7.2 Reactor Protection (Trip) System (RPS)—Instrumentation and Controls

The information in this section of the reference ABWR DCD, including all subsections, tables and figures, is incorporated by reference with the following departures and supplements.

Figure 7.2-5 Division 1 Trip Logic Coincident and Non-Coincident NMS Trips

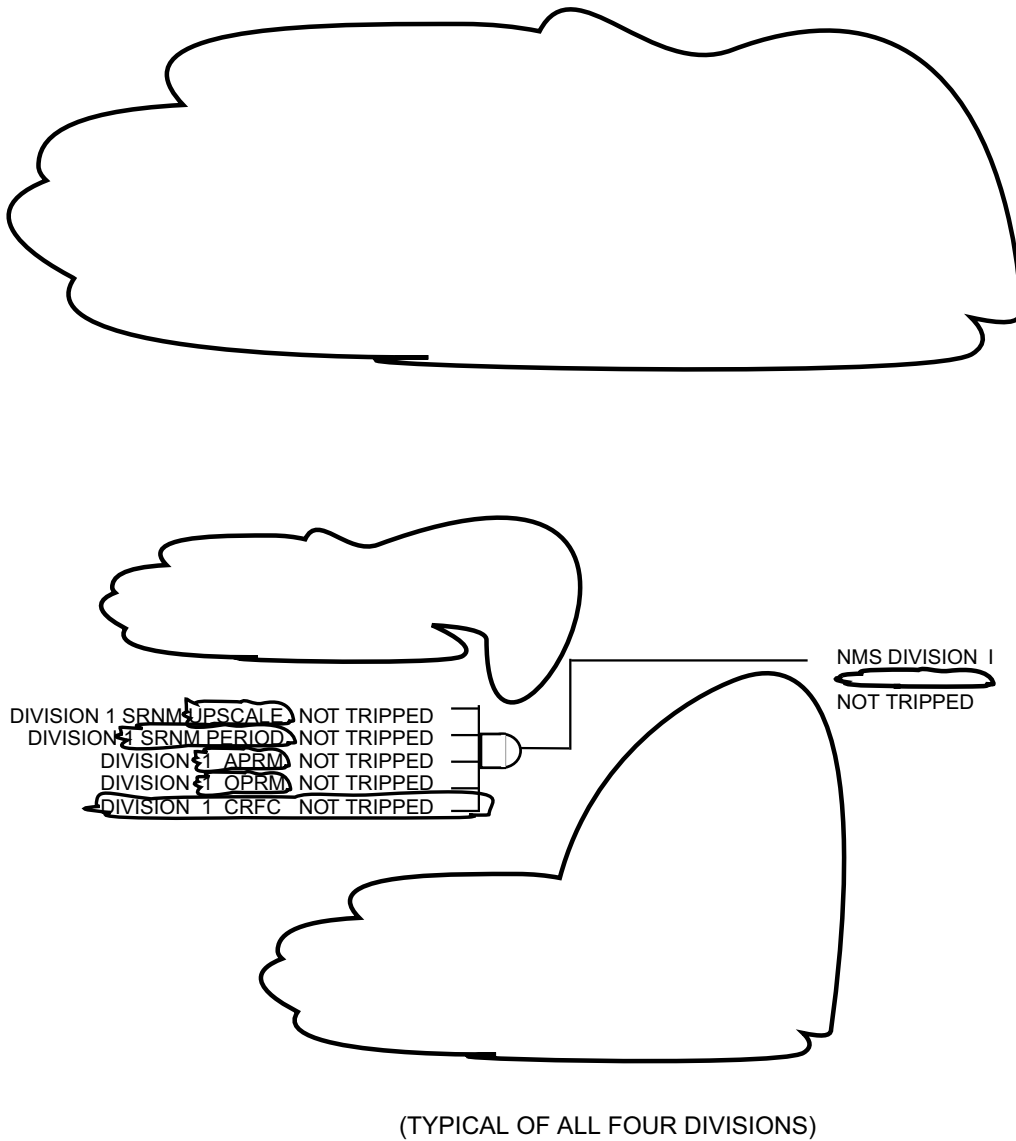
Each of the four divisions of the NMS equipment provides separate, isolated, ~~bistable~~ SRNM trip and APRM trip signals to all four divisions the corresponding division of RPS trip logics (Figure 7.2-5).

Neutron Monitoring System Trips (Figure 7.2-5)

~~A coincident NMS trip will occur in each division of trip logic when any two or more out of four divisions of APRM or SRNM trip signals are received from the NMS. The coincident SRNM trip is automatically bypassed when the reactor is in the run mode. The coincident APRM trip cannot be bypassed.~~

~~A non-coincident NMS trip will occur in each division of trip logic when any single APRM or SRNM trip signal is received from the NMS. The non-coincident NMS trip is automatically bypassed when the reactor is in the run mode. When the reactor is in the shutdown, refuel or startup mode, the non-coincident NMS trip can be manually bypassed in each division by a separate, manual, keylock non-coincident NMS trip disable switch.~~
